Project Address: 801 Erin Street
Application Type: Demolition and Rezoning
Legistar File ID #: [31423](#) and [31545](#)
Prepared By: Heather Stouder, AICP, Planning Division
 Report Includes Comments from other City Agencies, as noted

Project Updates and Additional Information

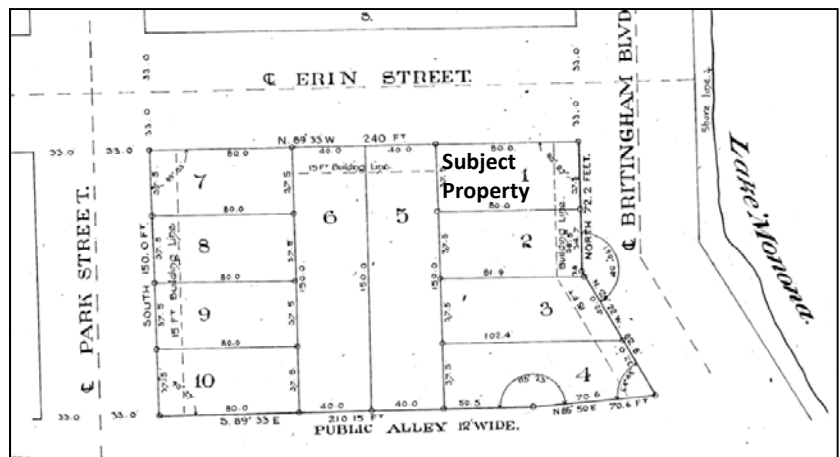
Further, as mentioned by City Engineering staff in Condition No. 2, the Spohn-Levander Replat for this block, which was approved in 1917, actually set a 15-foot "building line" on the eastern edge of these properties, facing West Shore Drive and Monona Bay (see figure at right). This line impacts the three existing homes on this block (Lots 2 and 3 have since been combined), but was not adhered to by the existing house on the subject property. The main front wall of the proposed home will bring this back into compliance.
